REPORT NO. B-2044

Test on Horns, Type H-4

Horns, Type H-4

The Sparks-Withington Company
Jackson, Michigan

PLATE 1

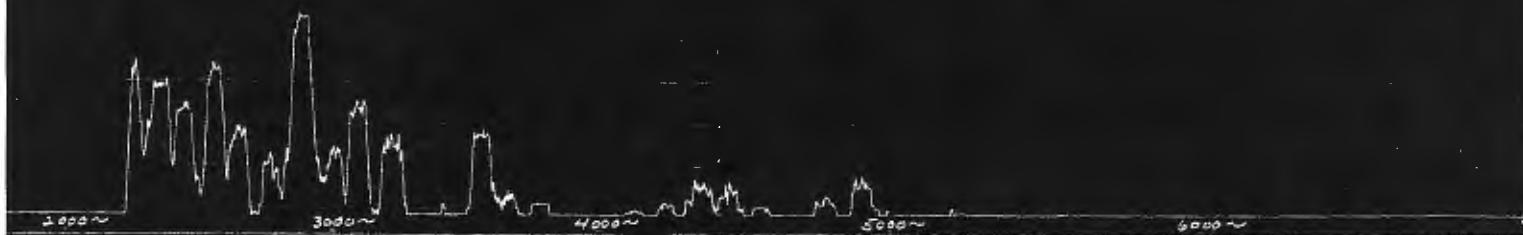
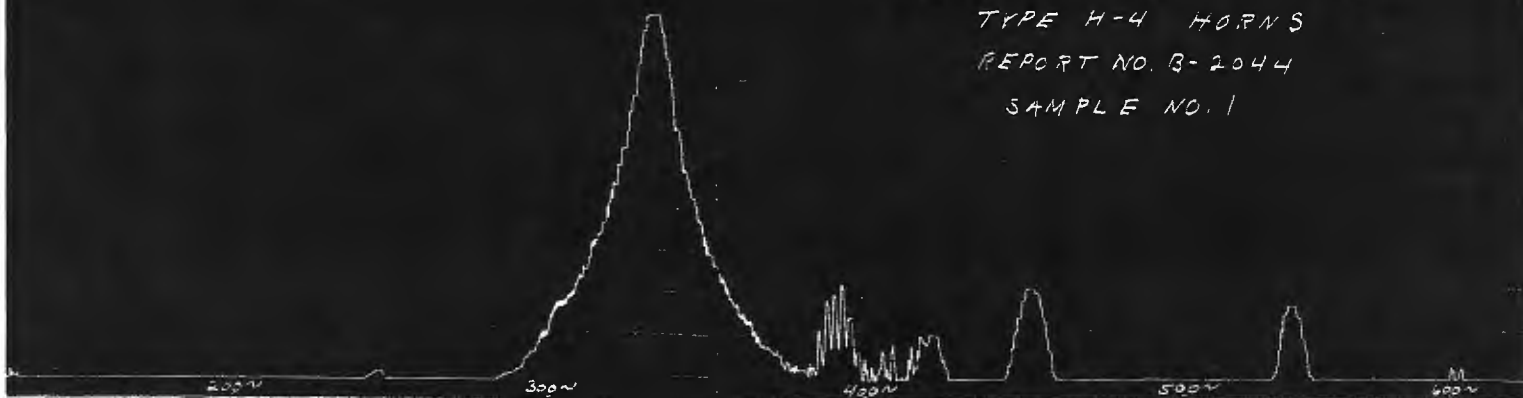
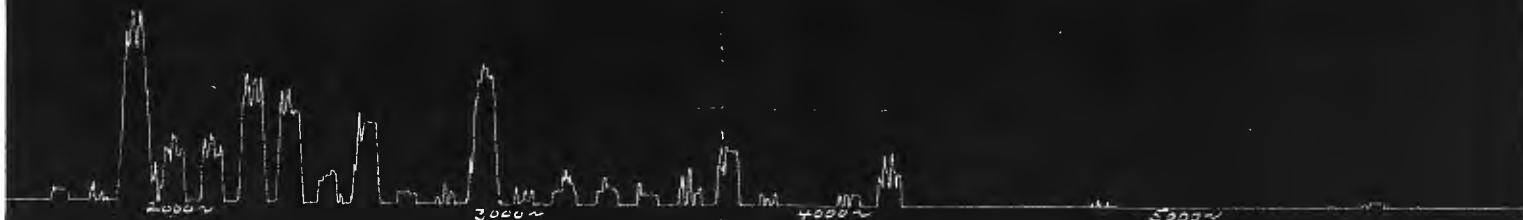
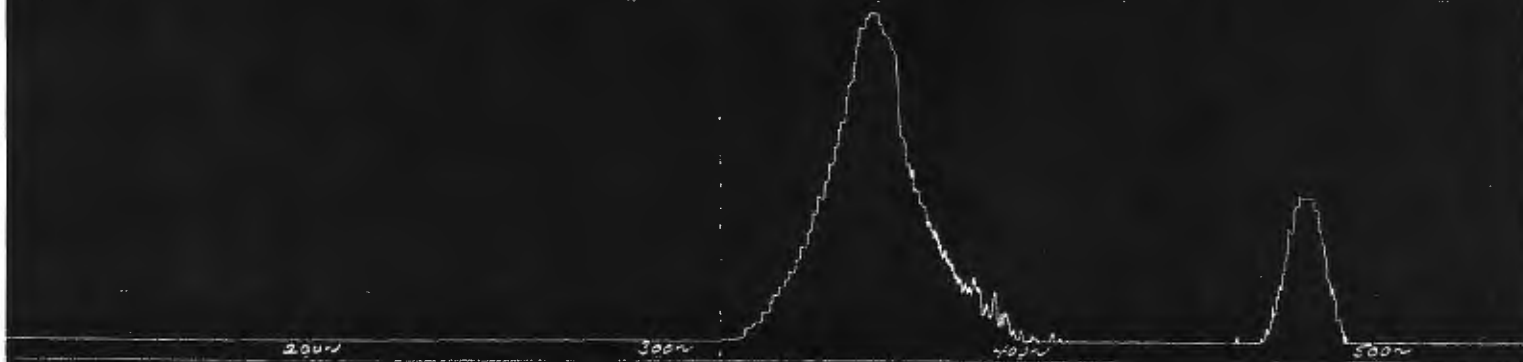
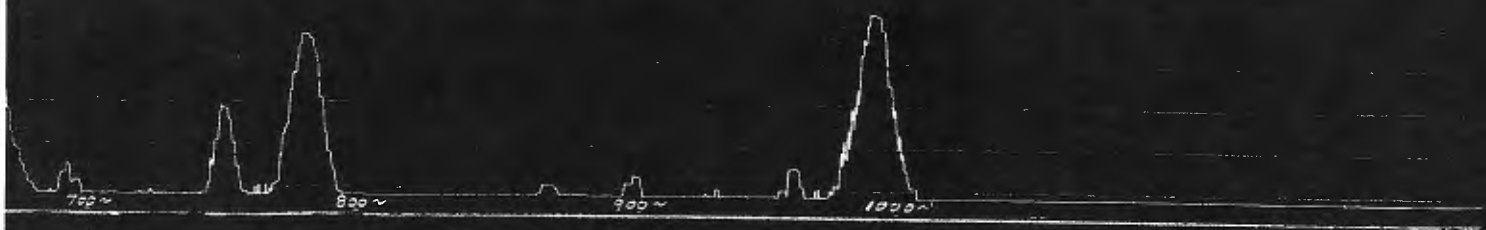
8. The acoustical analyses of the sample horns are given by Plate 1. Further details in the design and construction of the horn are shown in photographs, Plates 2 and 3. Drawing, reference (d), shows details of the case and cover correctly, but covers a different type of mechanism.

PLATE 4

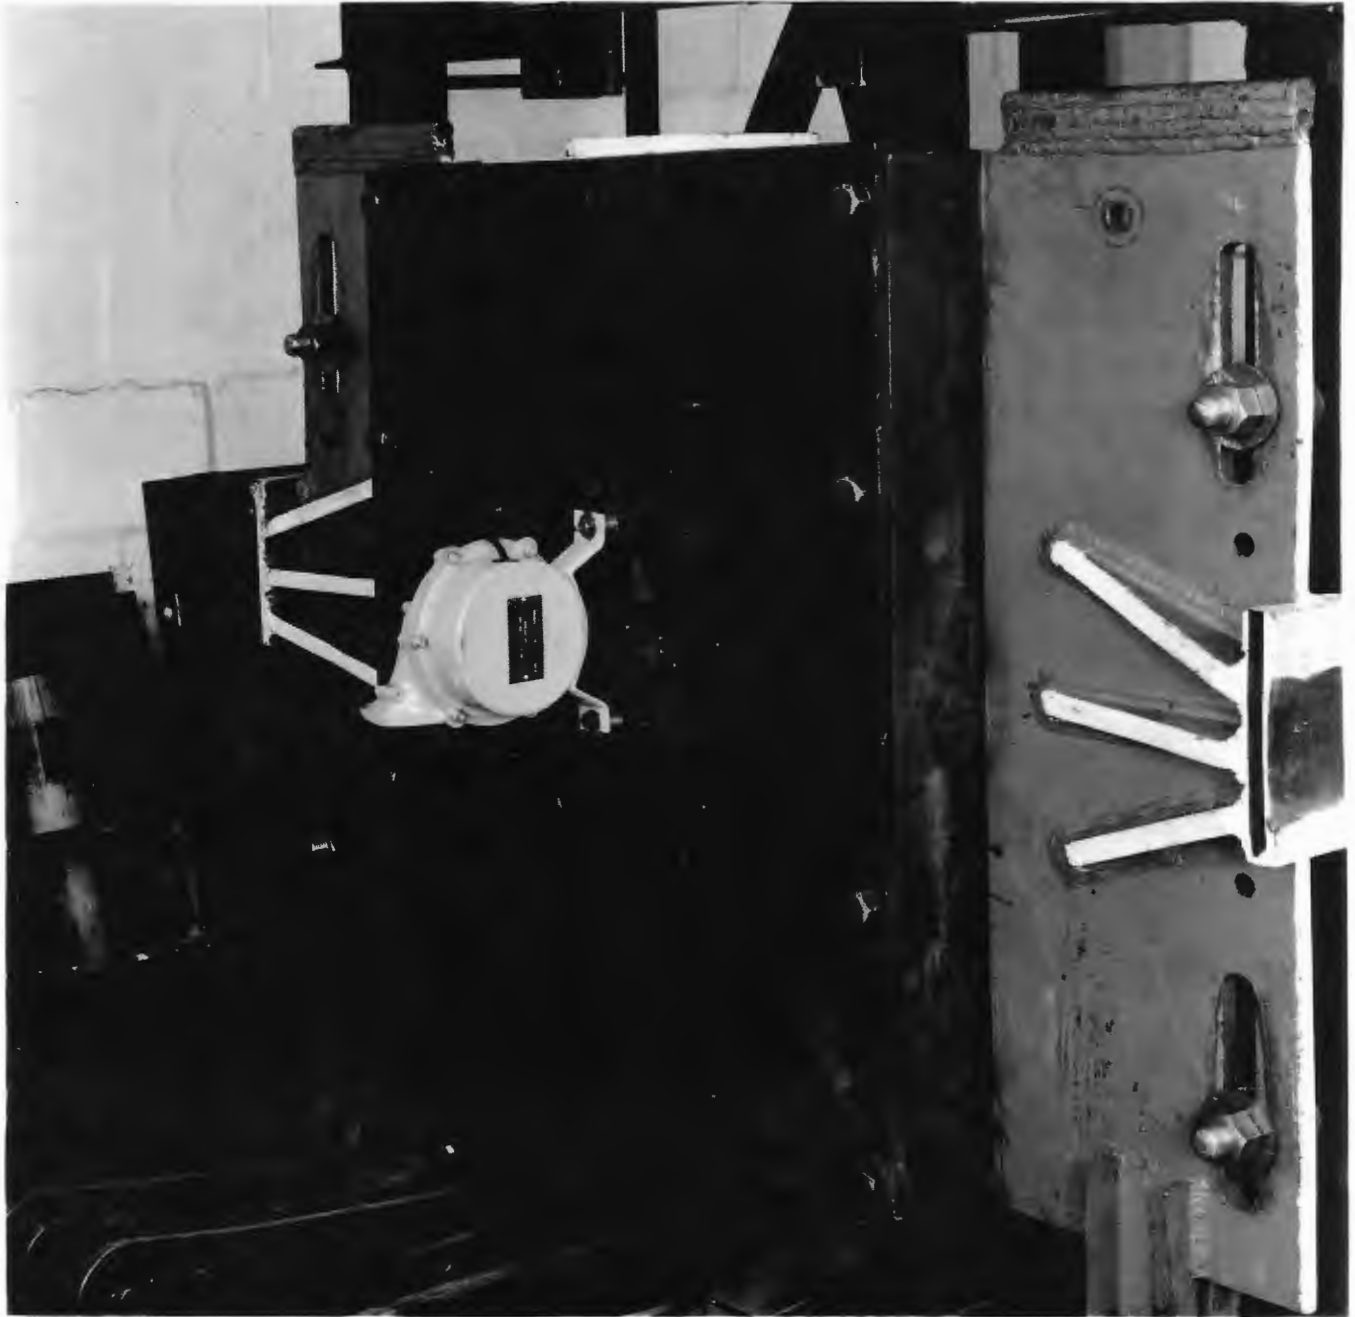
13. The third blow (back) of the HI shock test resulted in the contacts becoming out of adjustment and the case was slightly torn at the mounting strap welds. Following adjustment of the contacts, the remaining three blows resulted in no change except increased tearing of the case.
